MEMORANDUM

Revised Master Plan and Phase I Development Plan for Laurel Rock Reserve Major Subdivision (2008-M11)

Henderson County Planning Department Staff Report

Revised Master Plan & Phase I Development Plan for Laurel Rock Reserve (2008-M11)

SHEET RT1

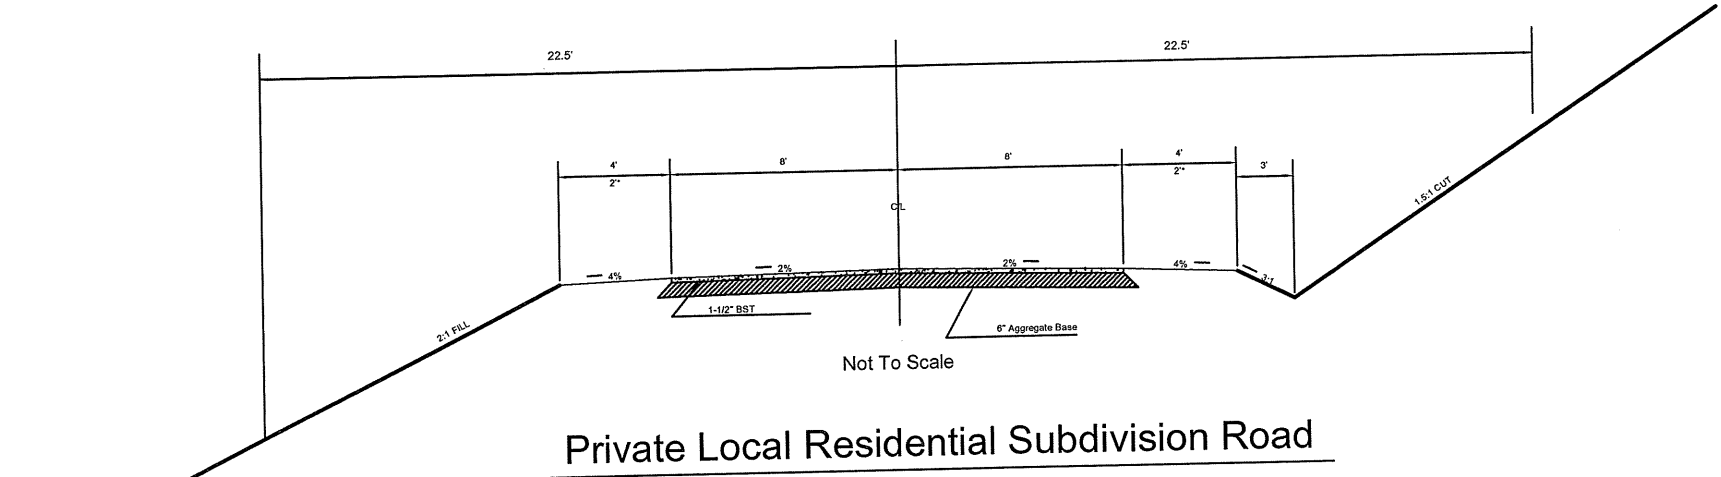
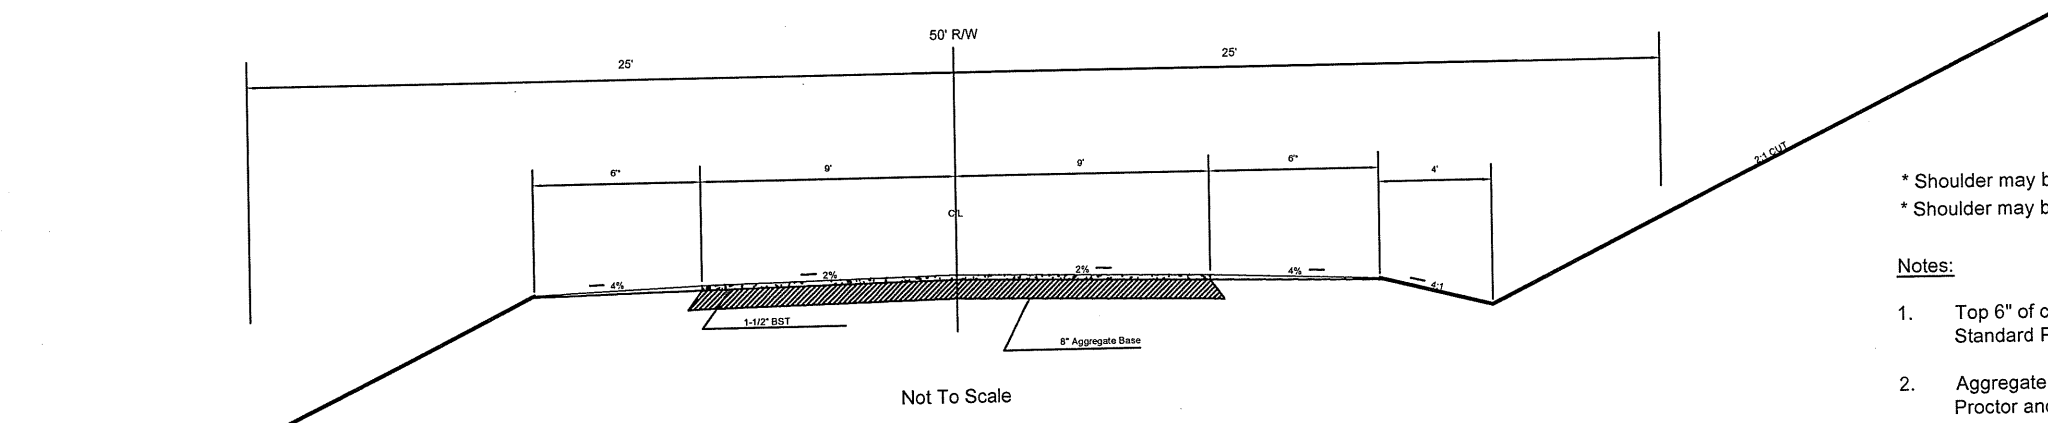
The current Master Plan approval provides the condition that the Applicant provide the appropriate cross section for Clark Gap Drive with the Phase I Development Plan submittal. This condition should be extended to the Revised Master Plan approval. The Applicant has

provided the appropriate cross section (See Attachment 9, Phase I Development Plan Sheet RT1).
